20th March 2025

Ref: 22016

**DA2024/0460 - 1-3 GONDOLA ROAD, NORTH NARRABEEN
PROPOSED SHOP TOP DEVELOPMENT**

**Manoeuvring Path of Australian
Standard AS/NZS2890.1:2004
B85 Vehicle Entering Basement and
B99 Vehicle Departing Basement**

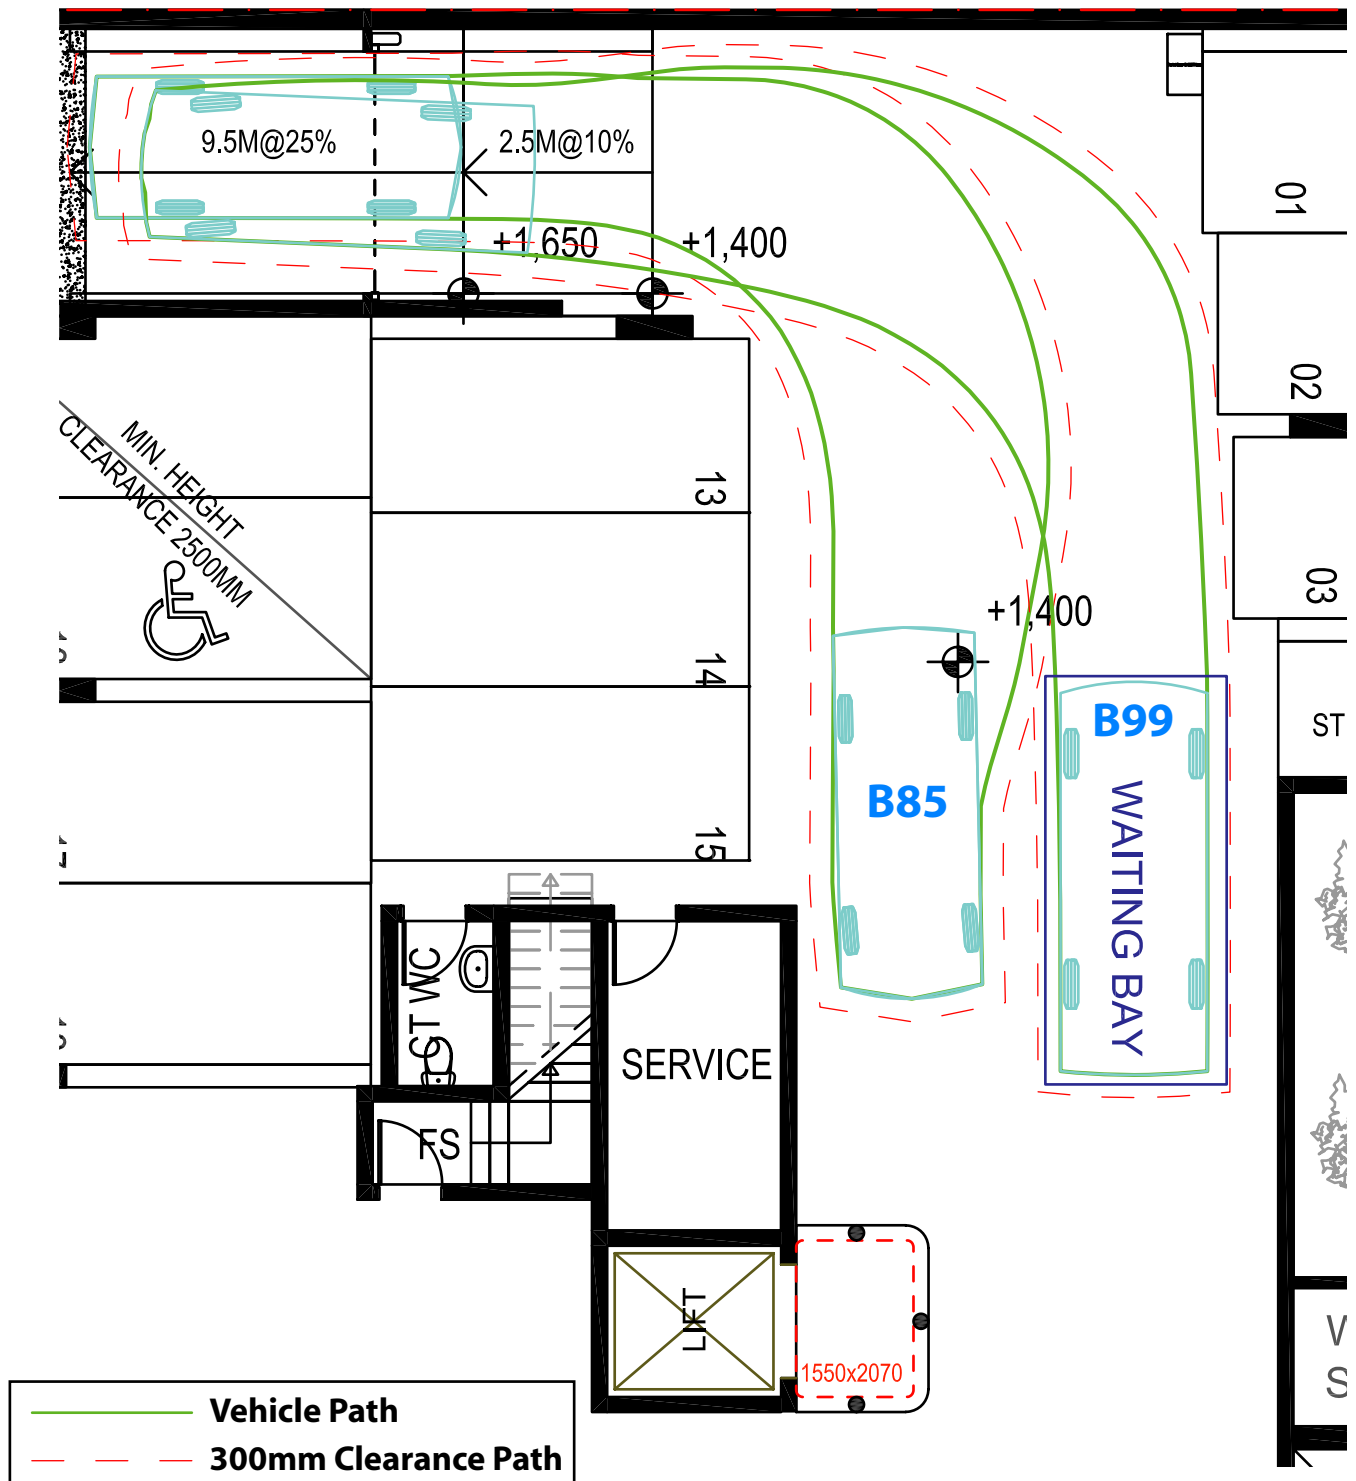
- It is noted that an entering vehicle is required to wait partially on a 12.5% ramp to give way to an exiting vehicle on the ground floor due to the one way ramp leading into the basement. Although the proposed one way ramp is acceptable with traffic signals, the waiting bay for the entering vehicle is not ideally located as it requires the vehicle to stop partially on the ramp. The waiting bay is however acceptable as there are no preferable alternative locations. The waiting bay must however be line marked and signposted. Also, a waiting bay for vehicles to stop to give way to entering vehicles in the basement level must also be provided. This bay must be shown to clear of the path of a vehicle entering the basement. These details must be provided. Council requires more details with regard to the siting, signage and line marking for waiting bays.*

The amended plans show linemarked waiting bays in the basement and the ground floor. The swept path of the Australian Standard B85 vehicle entering the basement and B99 vehicle exiting the basement from the waiting bay is reproduced in the following pages.
